SERVICE BULLETIN

DATE: 12 JULY 1997

* Supersedes SB900-012, Dated 05 February 1996. Revised to correct typographical errors.

CONDENSER SCOOP INSTALLATION

Figure 1. Condenser Scoop Installation

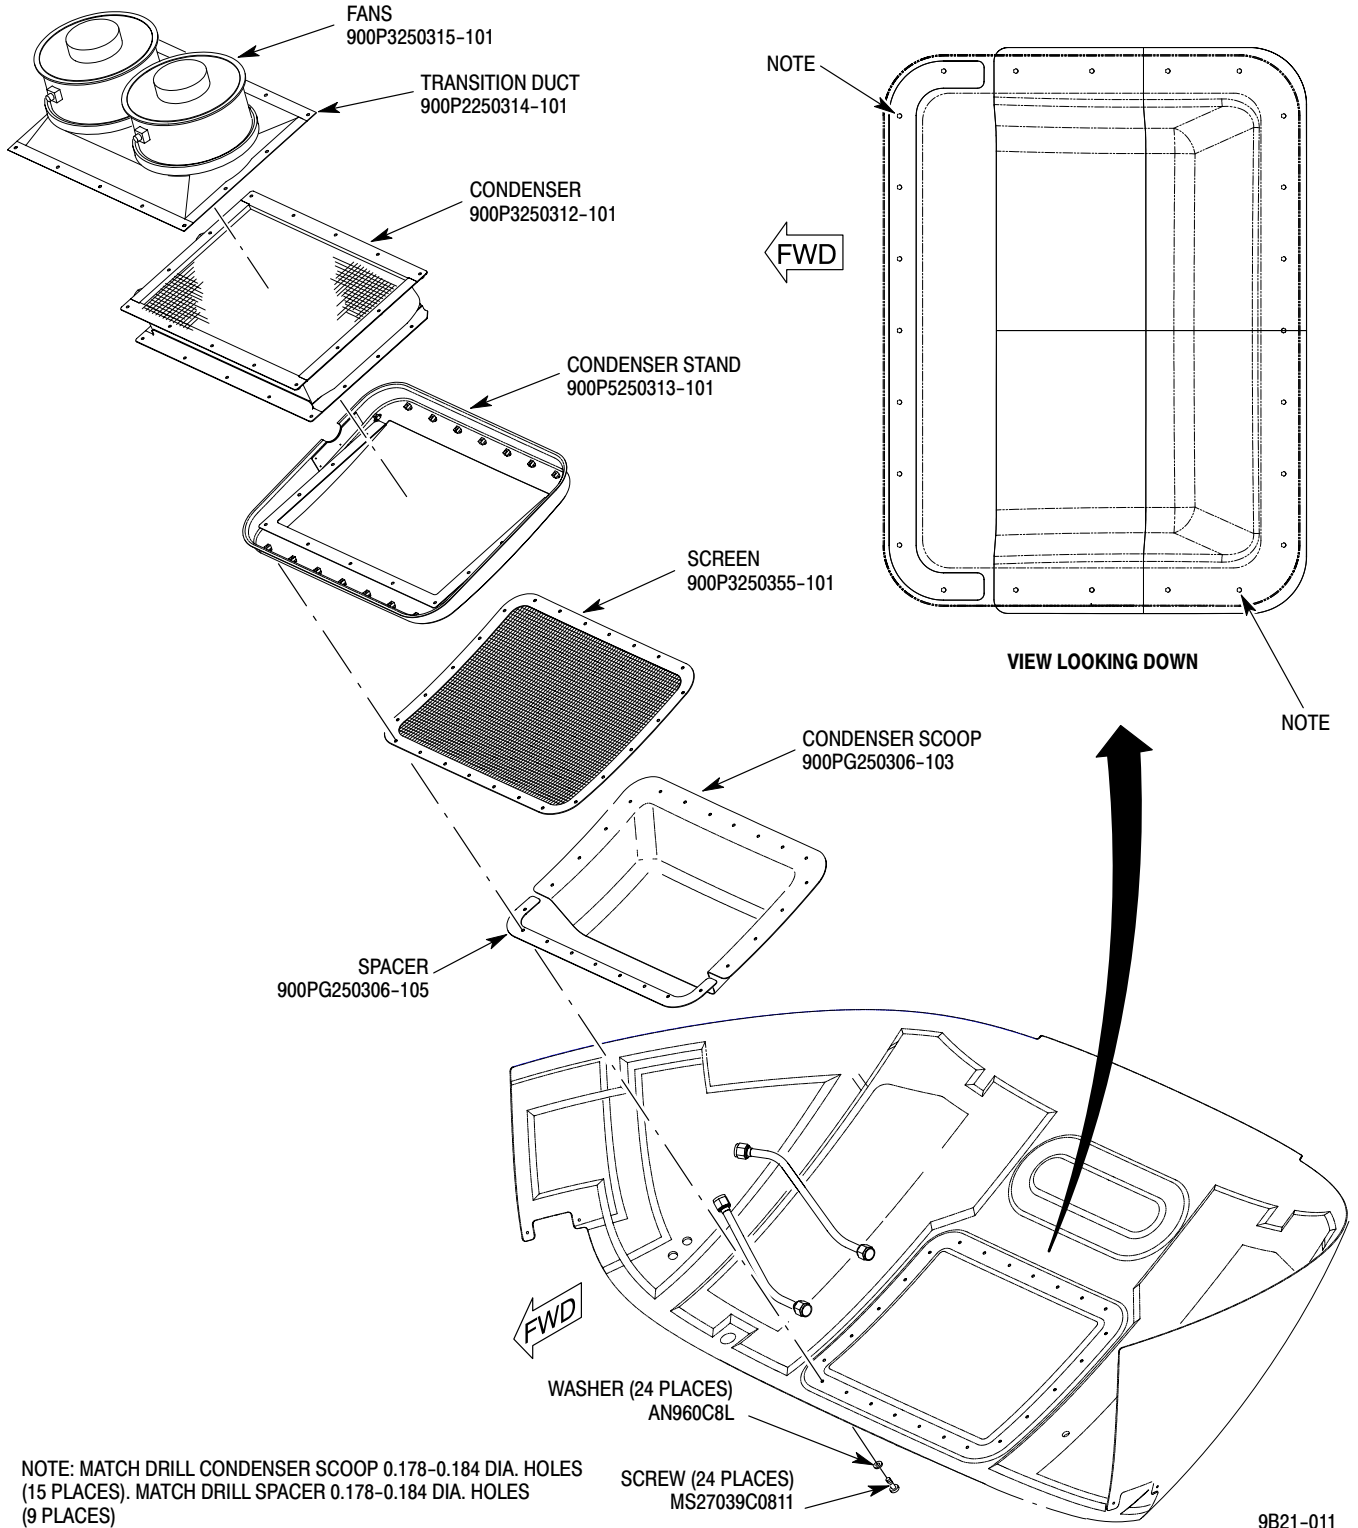
To increase the efficiency of the MD900 air conditioning system. The condenser scoop installation directs additional air thru the condenser during forward flight. With the condenser scoop, the efficiency of the air conditioner is maximized.

This Bulletin contains a list of parts and instructions to install the condenser scoop air inlet duct to the fuselage boat-tail tub. The instructions in this Bulletin refer to maintenance practices contained in CSP-900RMM-2.

- (1). Remove baggage floor panel A235 (Ref. Section 53-20-00).
- (2). Remove screws (MS27039C0810) and washers (AN960C8L) from condenser stand and screen (24 places, Ref. Figure 1).

NOTE: Screws will be replaced with longer screws (MS27039C0811). Retain washers for reinstallation.

- (3). Install condenser scoop and spacer through the bottom opening and rotate into position while condenser stand is raised.
- (4). Locate condenser scoop and spacer as shown in figure 1. Match drill **0.178-0.184 inch dia. (4.5-4.7 mm)** holes, #15 drill size (24 places).
- (5). Deburr holes in condenser scoop and spacer.
- (6). Install condenser scoop, spacer, air screen, and condenser stand in sequence as shown in Figure 1.

- (7). Wet install screw (MS27039C0811) and washer (AN960C8L), (24 places) with sealing compound (C205).
- (8). Torque screws **12-15 in-lb(1.4-1.7 Nm)**.
- (9). Install baggage floor panel A235 (Ref. Section 53-20-00).
